Attached are the 2 informal estimates that you asked for at Kingston Steam Plant. These estimates are for talking purposes only and are not to be used as budget estimates

SUBJECT Relocate 6 Spillway Structure PROJECT _____Away From Intake ChannelCOMPUTED BY W. M. Martin DATE 9/10/85 CHECKED BY _____ DATE _____

SUBJECT Add 4-10 ft. Diameter Pipes PROJECT KIF

SUBJECT Concrete Flume - Reroute Spillway

I) RESOLUTION OF DICH. TO DIKE "C"

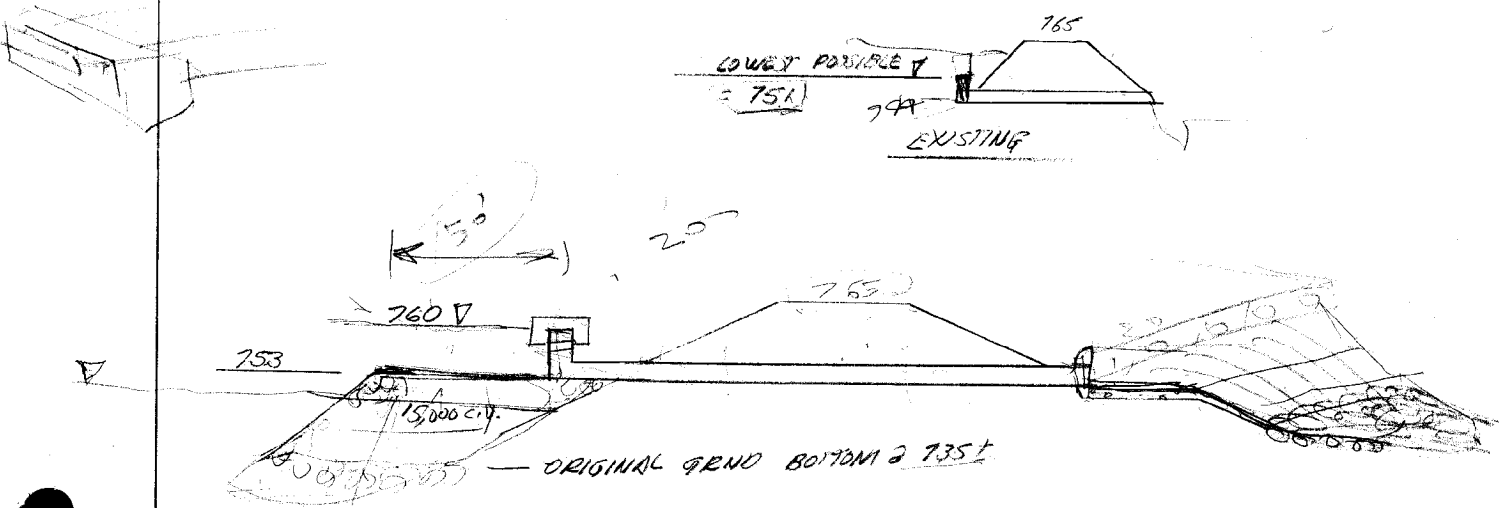
- 1.) NOTE: LEAVE EXISTING SPWY "AS IS" (DO NOT PLUG) 1.) WILL BE USED WHEN NECESSARY TO LOWER WATER LEVEL - NEW 12" MIN EL 760
- 2.) WILL USE EXISTING WHILE CONST. NEW SPWY.

2.) MUST CONSTRUCT DEFLECTOR DIKE DUE TO SHORT CIRCUIT.

- 3.) REPAIR "C" LEAK
- 4.) CONST. CONCRETE DISCH. TROUGH
- 5.) EXST. EST IS UNDER ESTIMATED @ 150,000 TOT. FIELD CONST.

II. CONC. FLUME - UNDER ESTIMATED @ 139,000 T.F.C. (UNDER SPEED)

III. 4-10' PIPES - UNDER ESTIMATED @ 106,000 T.F.C. (DON'T KNOW IF ACTUAL TEMP MIX FALL)

QUESTION: HAS IT BE PROVEN THAT THE POND DISCH. IS SIGNIFICANT IN TEMP. PROBLEM. VOL OF INTAKE MIX IS QUITE LARGE
